CITY PLANNING COMMISSION

LOCATION: 1150 Larkin Way

PROPOSAL: The applicant is requesting the necessary entitlements to develop an eight-unit townhouse development.

APPLC. NO. P82-191

SITE PLAN

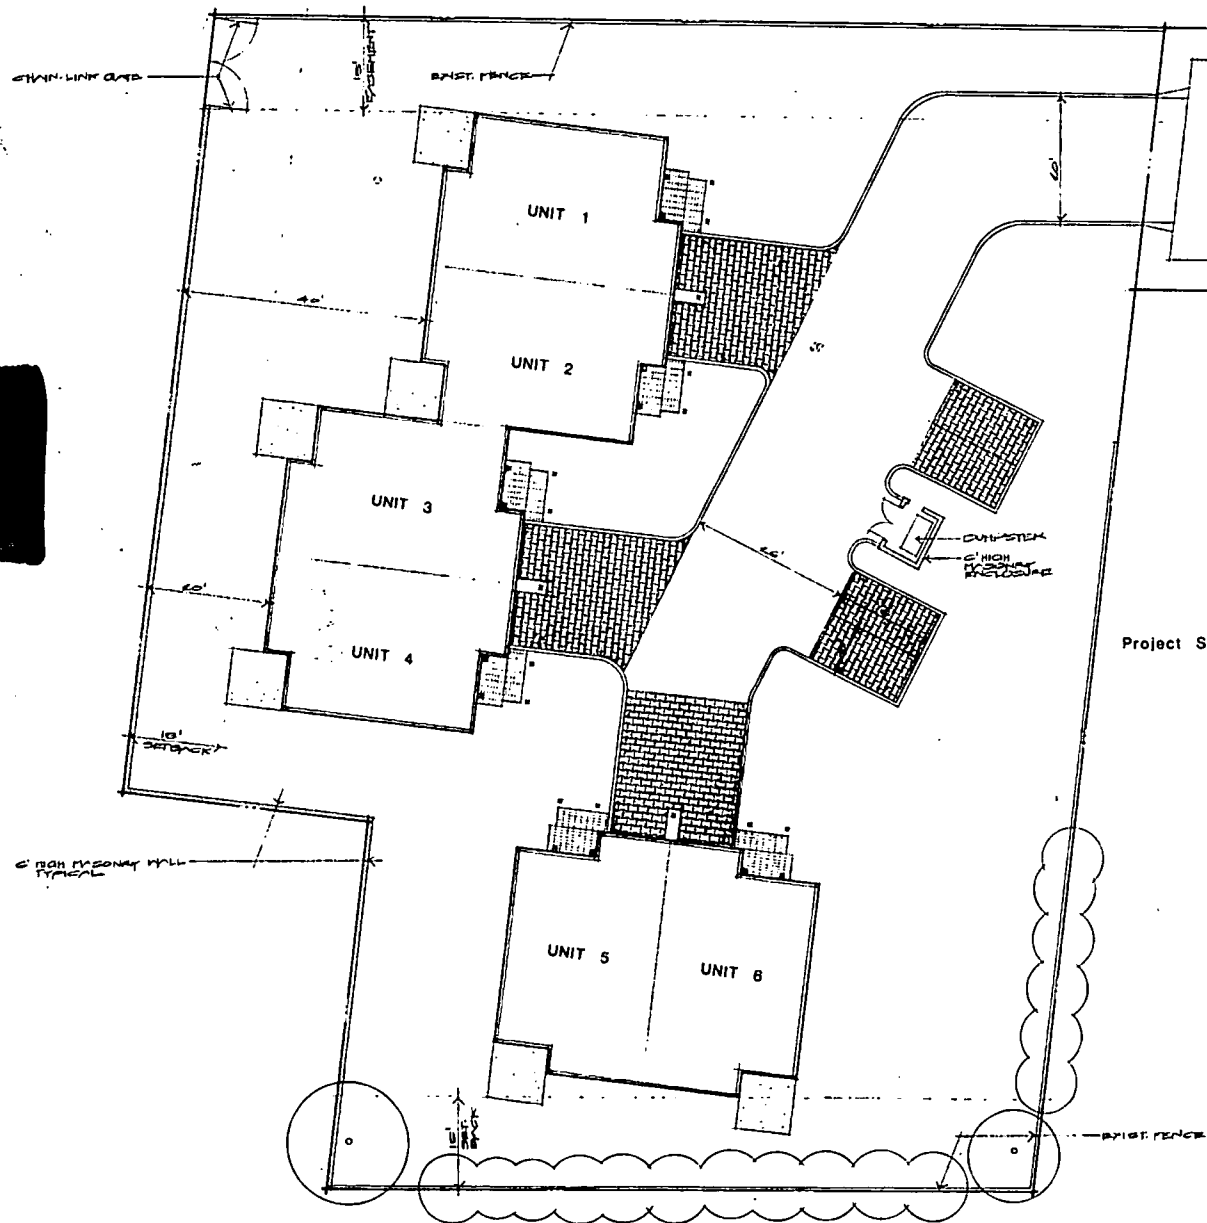
Note: Driveway for Units 3 through 8 should be 24 feet in width.

2. The three variance requests are reasonable and justifiable on the grounds that the lot is irregular in shape. The addition of the required cul-de-sac within the development will cause an even greater irregularity of lot shape and elimination of open space fronting the units.

In respect to the front setback reduction, only five feet of the garages of Units 1 and 2 and two feet of the dwelling entrance of Unit No. 1 project into the required 25-foot setback area. Therefore, the front setback is reduced to 20 and 23 feet. The applicant, however, has provided a 15-foot side yard on the north side of Unit No. 1. The Zoning Ordinance requires a five-foot setback. Staff believes this additional open landscaped area compensates for the front setback reduction. In respect to the rear setback reduction, only three feet of Units 1, 2, 3 and 4 project into the 15-foot rear yard area. This projection is only a portion of the first floor of the four units. The second floors are set back 15 feet. This reduction will not impact the adjacent properties in that the adjacent uses to the west are commercial, and a six-foot high masonry wall will be required along the west property line. The three off-street parking spaces located in the front yard setback will allow for on-site guest parking rather than on-street parking. The area surrounding these spaces will be landscaped and turf block will be required for this paved area to soften the appearance of the continuous pavement in the setback area.

4. In respect to the proposed guest parking, staff suggests the applicant redesign these spaces by designating the two southerly spaces as compact and by reducing the stall depth of all four spaces. This would reduce the paving area and increase the landscaped area. The turf block element will also improve the appearance of the parking area.

- c. Applicant shall submit the project to the Design Review/Preservation Board for review and approval;
- d. The applicant shall redesign the guest parking area to include the following:

- 1) turf block or gridiron shall be used as surfacing material;
 - 2) the southerly parking spaces shall be designated as compact spaces;
 - 3) the depth of the parking shall be reduced to increase landscaped area;

- 4) a 6-inch by six-inch concrete curb shall be installed between planting and parking area.

FRONT ELEVATION

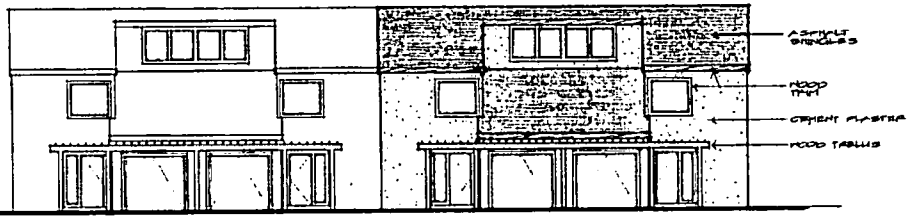
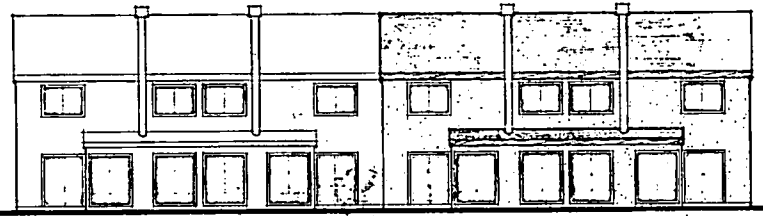
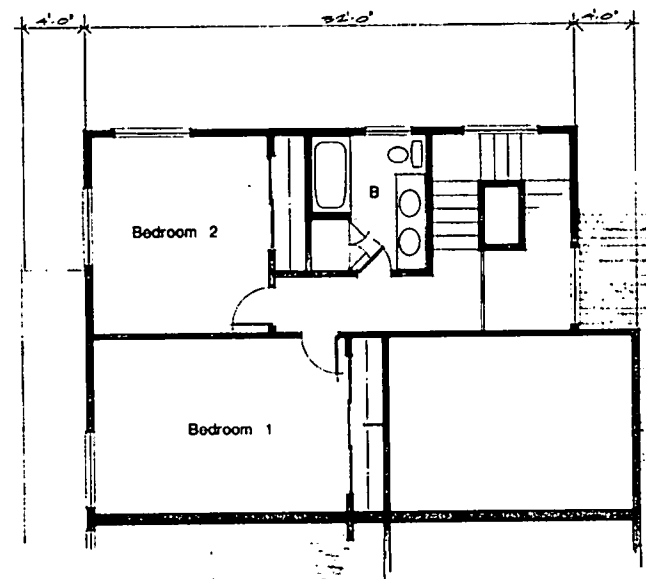
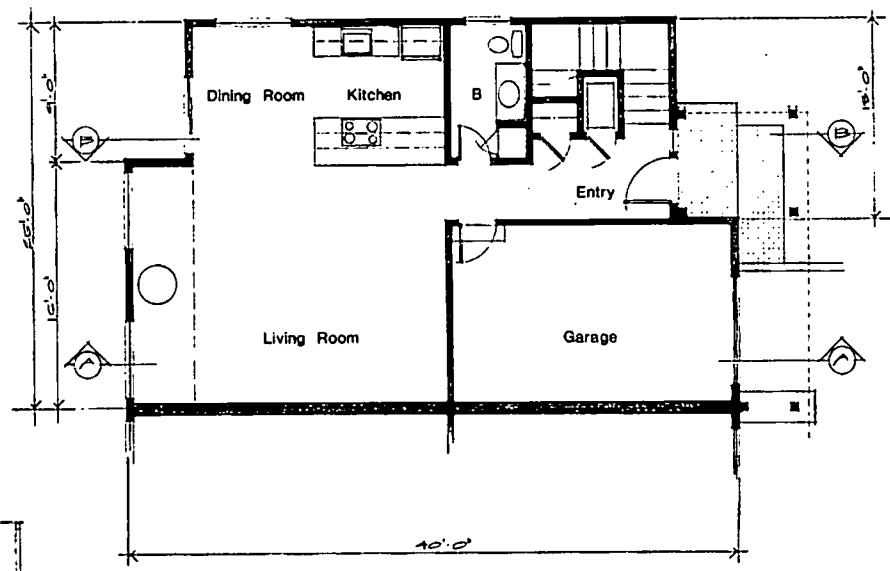
3. Staff believes that the project design is not compatible with or enhances the existing residential neighborhood which is composed of single story stucco homes with steep gable roofs. Project materials, silhouettes and proportions should not necessarily duplicate, but should be more compatible with the existing neighborhood. Therefore, staff believes this project should be reviewed by the Design Review/Preservation Board.
